**ATTACHMENT 3**  
**WALKDOWN CHECKLISTS**

**Seismic Walkdown Checklist (SWC)**

Project: CCNPP 1 SWEL

1SV5313A 8-8-12 104

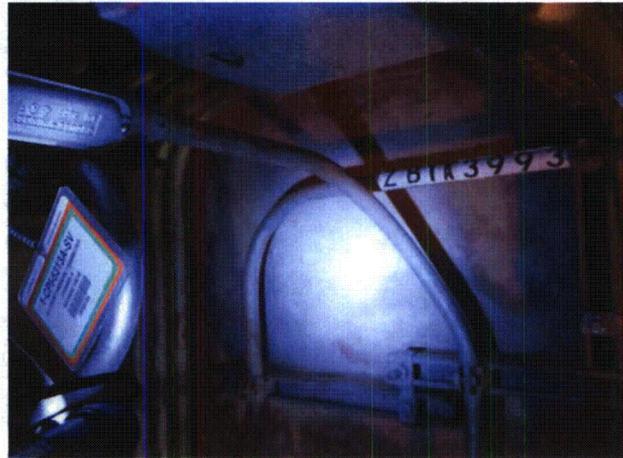
*Valve tubing is 1/8" away from PT's conduit. Conduit is flexible and not considered a hard target therefore judged not to be an adversely seismic concern for the SV.*

1TKBAST11 8-6-12 030

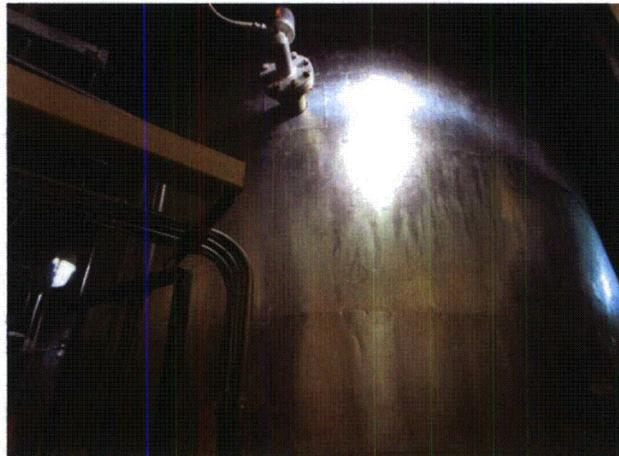
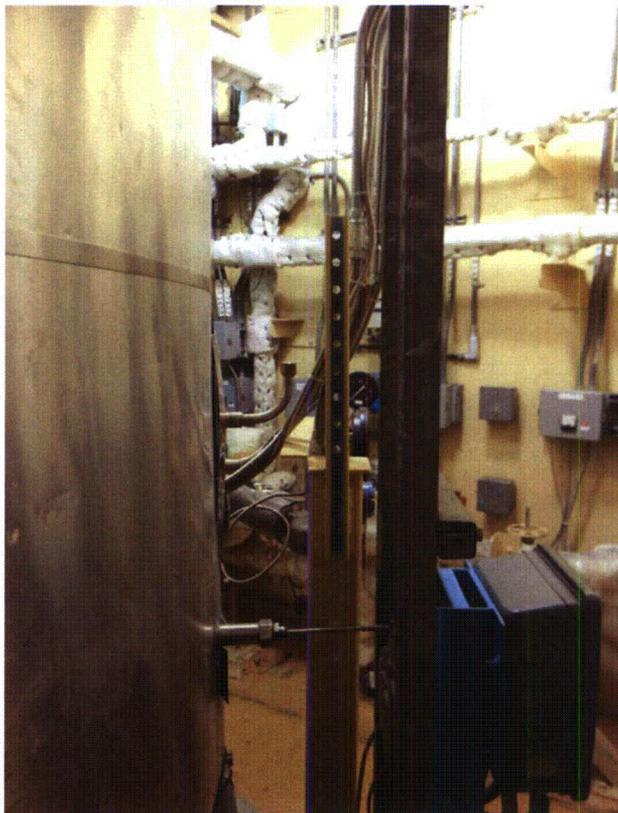
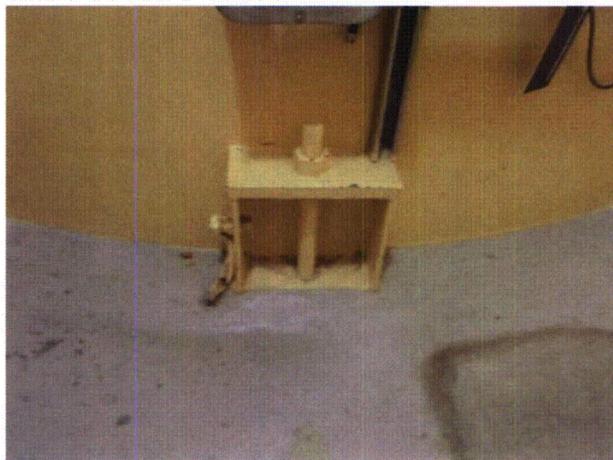
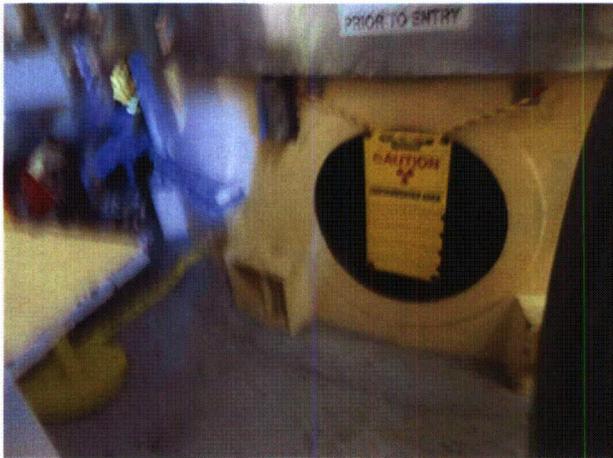
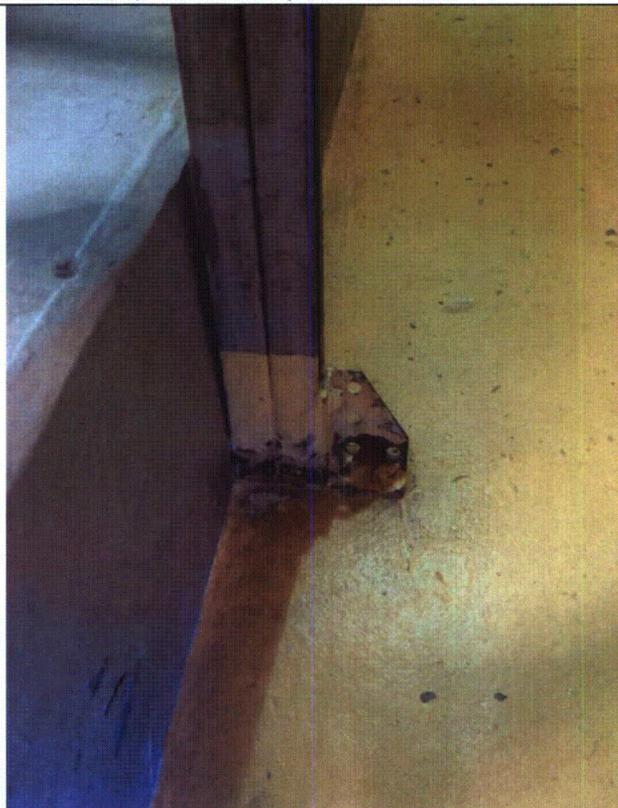
1. Is anchorage configuration verification required (i.e., is the item one of the 50% of SWEL items requiring such verification)? Yes  
*Confirmed anchorage base is consistent with C-013 calc (1-1/2" bolt).*

11. Have you looked for and found no adverse seismic conditions that could adversely affect the safety functions of the equipment? Yes
- A junction box support is pinned to floor. The support is approximately 8' tall. There are 2 - 2" conduits running from the JB to a trapeze hanger at the ceiling approximately 20' up. Nearby pipe and support above the JB support will restrain motion, therefore judged not an adverse seismic concern.*
-

1TKCCHD11 8-9-12 118

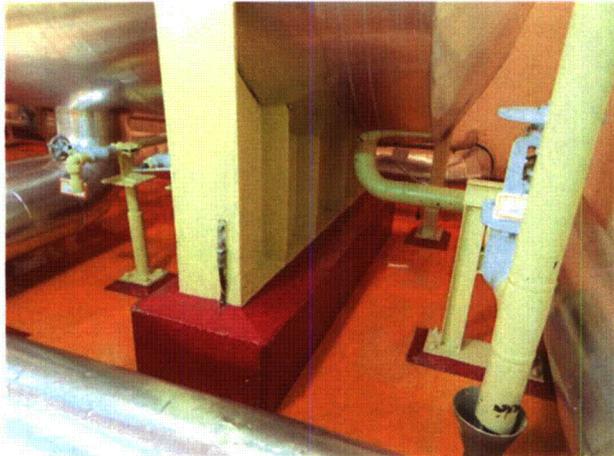
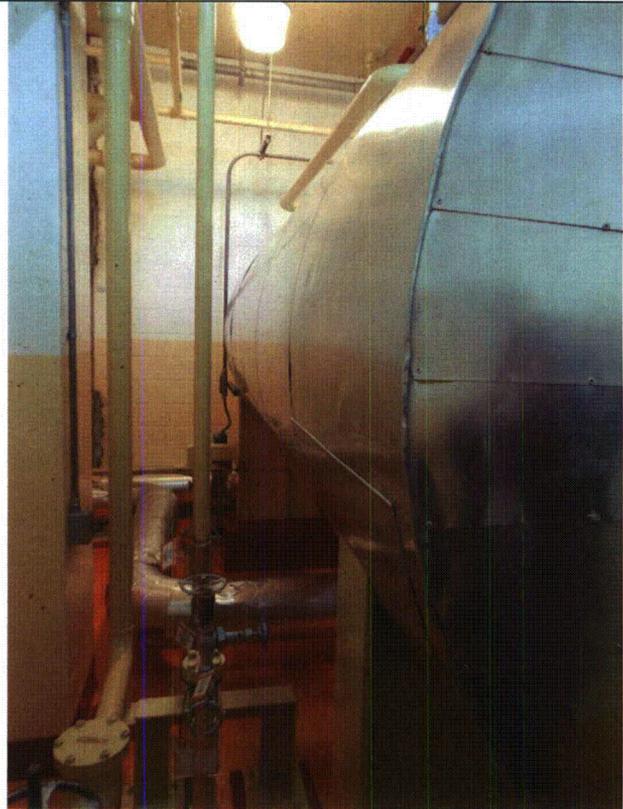
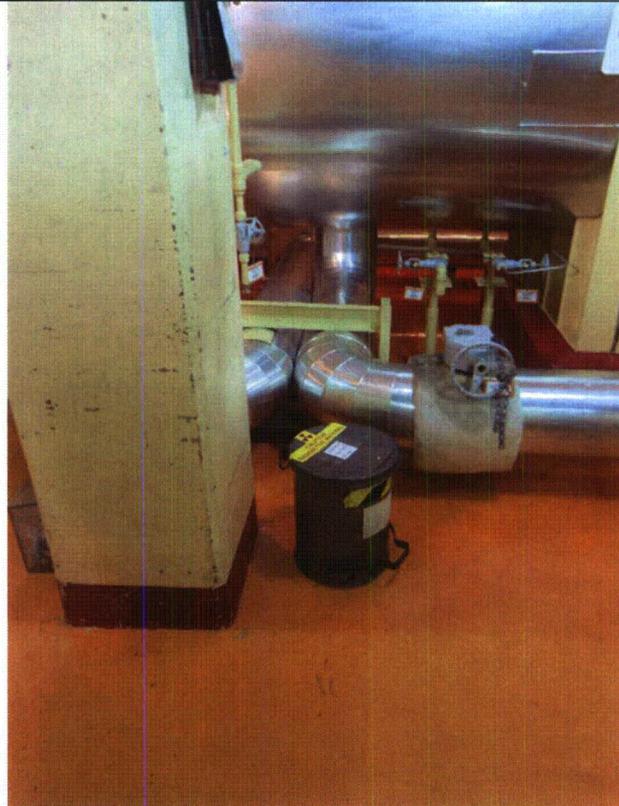
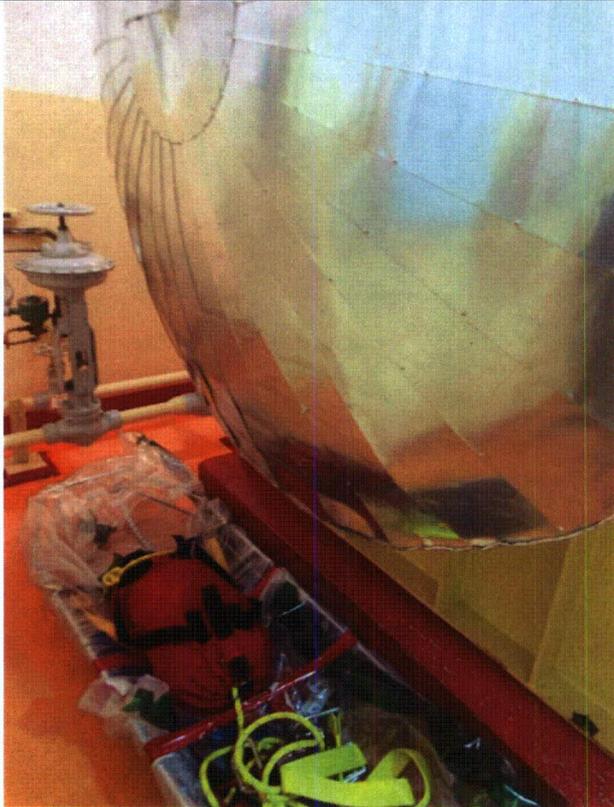
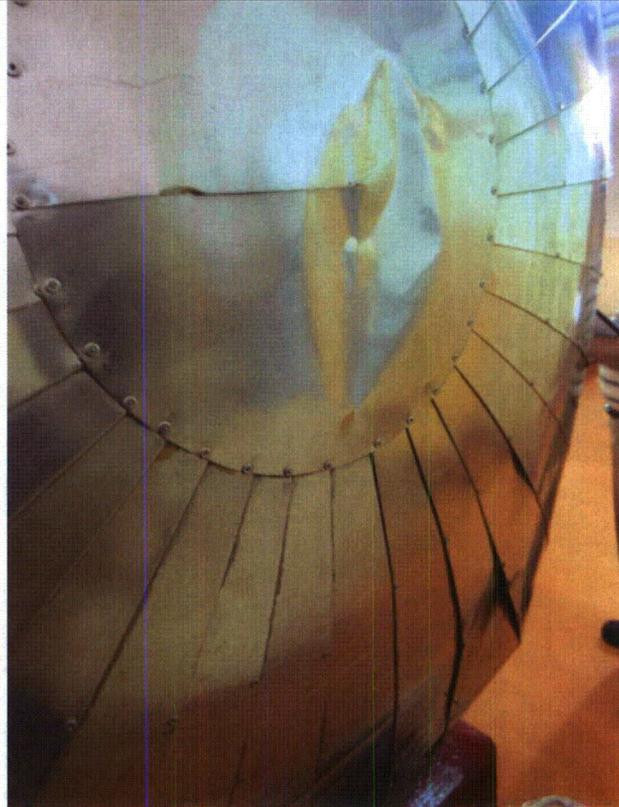
5. Is the anchorage configuration consistent with plant documentation? (Note: This question only applies if the item is one of the 50% for which an anchorage configuration verification is required.) Yes  
*Anchorage is consistent with drawing FSK-C-0389.*

7. Are soft targets free from impact by nearby equipment or structures? Yes  
*Piping support is in contact with the insulation jacket. The pipe support anchored to the ceiling and the tank to the floor. The differential motion will not affect the tank or piping, therefore judged not to be a seismic concern.*
8. Are overhead equipment, distribution systems, ceiling tiles and lighting, and masonry block walls not likely to collapse onto the equipment? Yes  
*Masonry block walls, identified as L and A12 on drawing A-260, are safety-related and thus seismically rated per IE Bulletin 80-11.*
9. Do attached lines have adequate flexibility to avoid damage? Yes
10. Based on the above seismic interaction evaluations, is equipment free of potentially adverse seismic interaction effects? Yes
-

11. Have you looked for and found no adverse seismic conditions that could adversely affect the safety functions of the equipment? Yes  
*There is a portable ventilation unit on wheels. The wheels are locked and therefore not a seismic condition.*
-

1TKCDSTG12 8-15-12 001

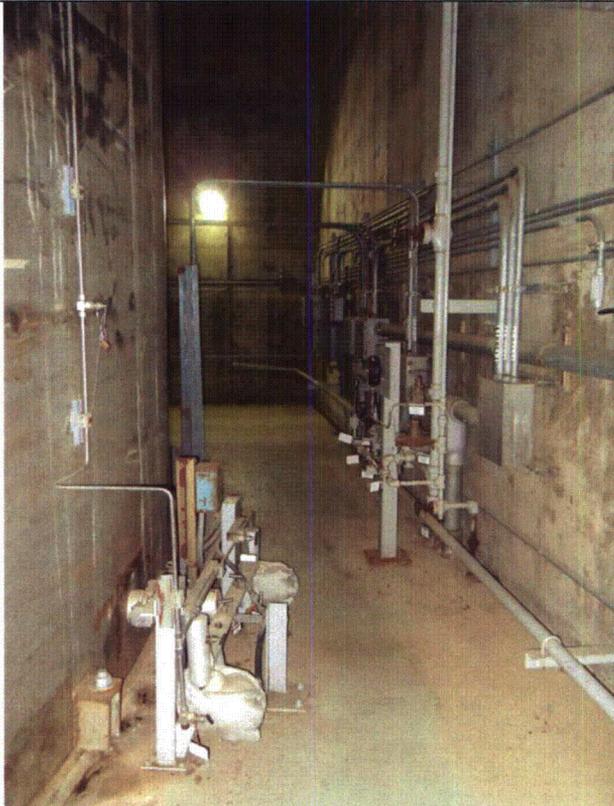
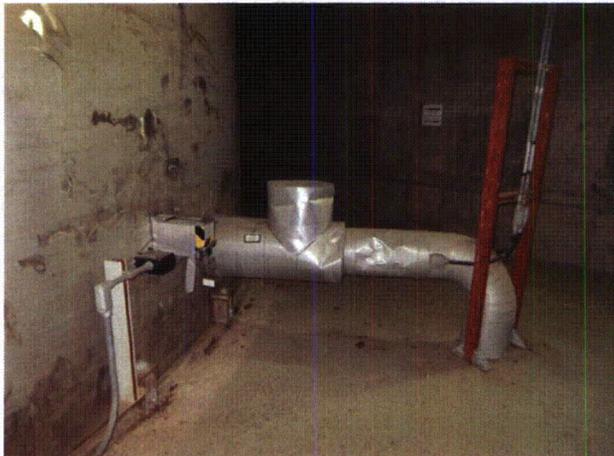
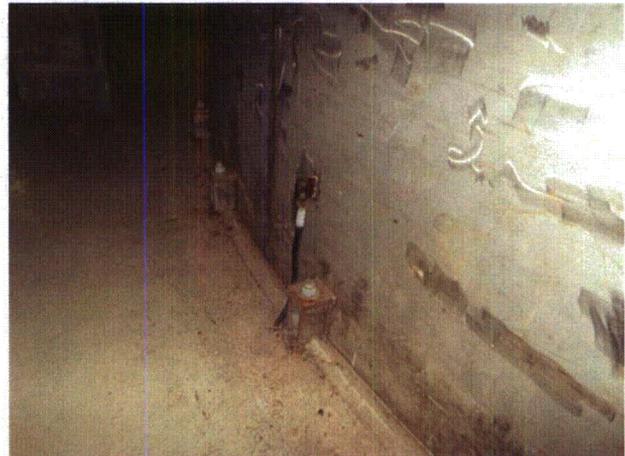
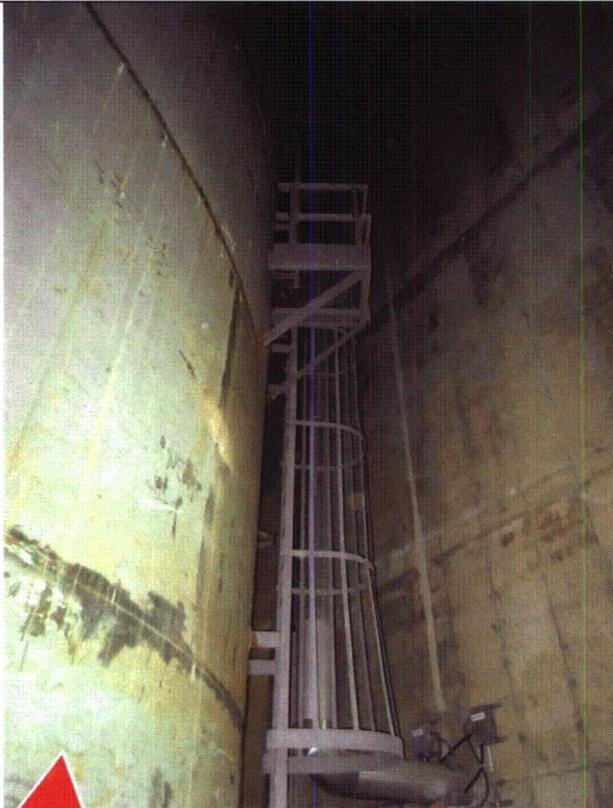
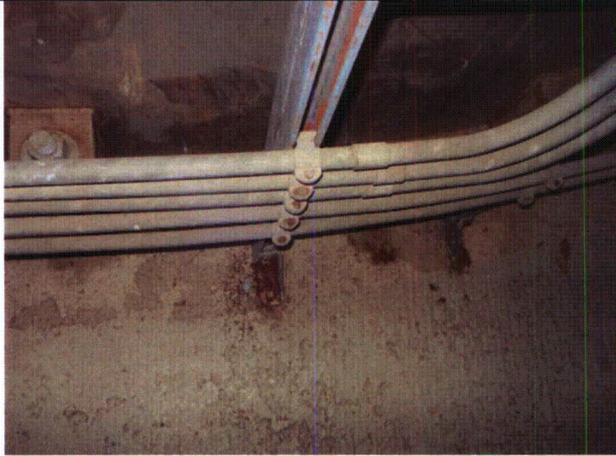
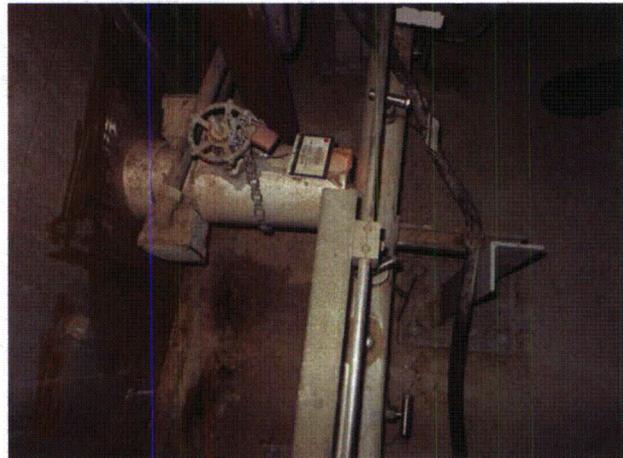
5. Is the anchorage configuration consistent with plant documentation? (Note: This question only applies if the item is one of the 50% for which an anchorage configuration verification is required.) Yes  
*Anchored by 36 - 1 3/8" bolts with an approximate 12" projection and 43" chord. Anchorage is consistent with drawing 12329C-0012.*

*Line with valve OHVCO-1015 is supported 16" from the tank and line with valve OHVOW 284 is supported 51" from the tank. Need to determine if there is adequate flexibility in these lines. CR-2012-009632 (OHVDW284) & CR-2012-009635 (OHVCD1015)*

*Corrosion on conduit support base clip angles, judged not to be a seismic concern.*

*10/29/12 - Tank anchor bolt elongation:*

*Bolt Dia. = 1.375 in; Area, A = 1.485 in<sup>2</sup>*

*Bolt Length, L = 48 in; E = 29000 ksi,*

*Load, P = 50.4 kip, based on GIP Appendix C*

*Elongation = PL/(EA) = 0.05618 in < 1/16"*

*The potential differential movement between the tank and adjacent pipe supports is less than 1/16". Given, the flexibility of the tank shell and pipe supports, the potential 1/16" differential motion is judged not to be a seismic concern.*

1TKDFO10025 8-15-12 066

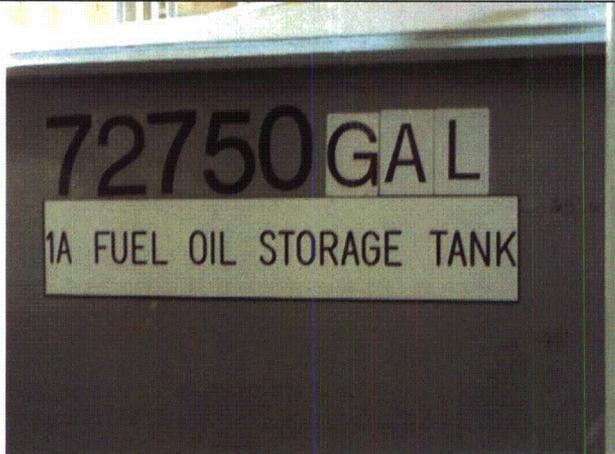
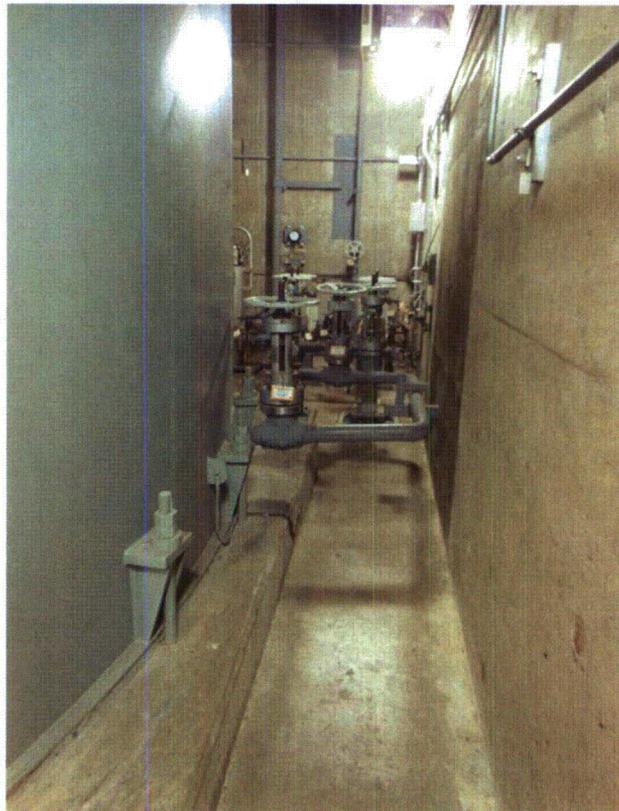
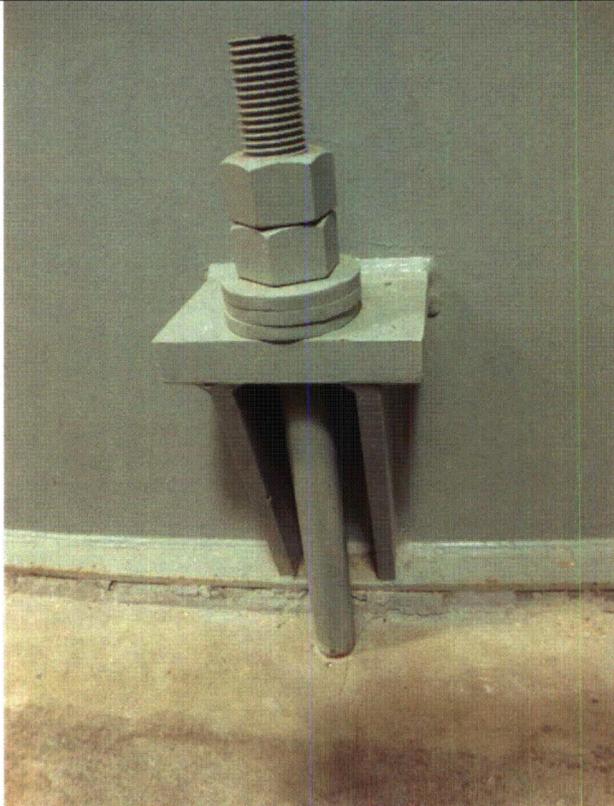
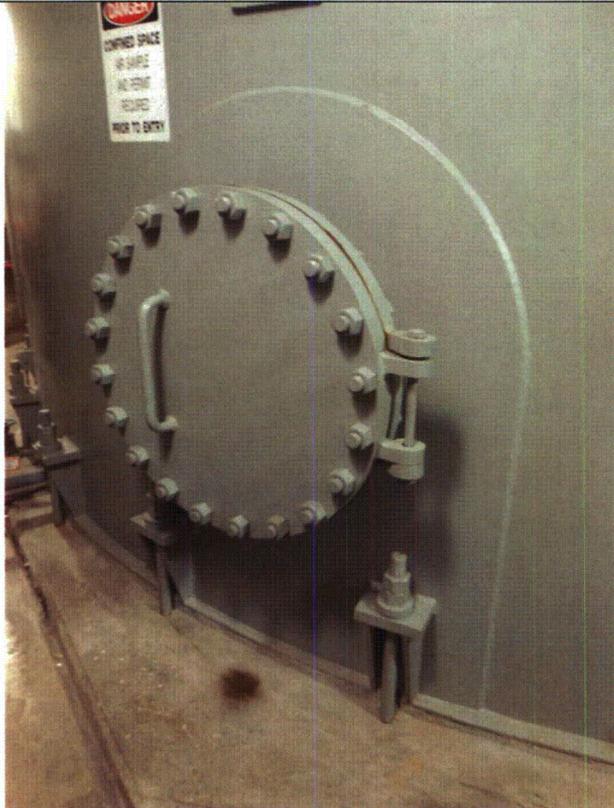
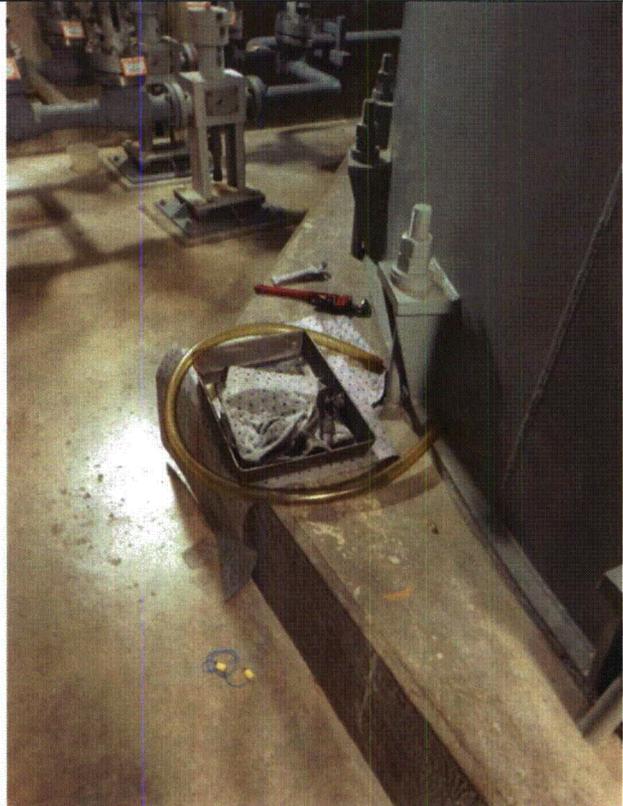
3. Is the anchorage free of corrosion that is more than mild surface oxidation? Yes  
*Only surface oxidation is present, therefore not a concern.*

4. Is the anchorage free of visible cracks in the concrete near the anchors? Yes  
*Minor surface finish concrete hairline cracks approximately 1" to 3" long, therefore not a concern.*
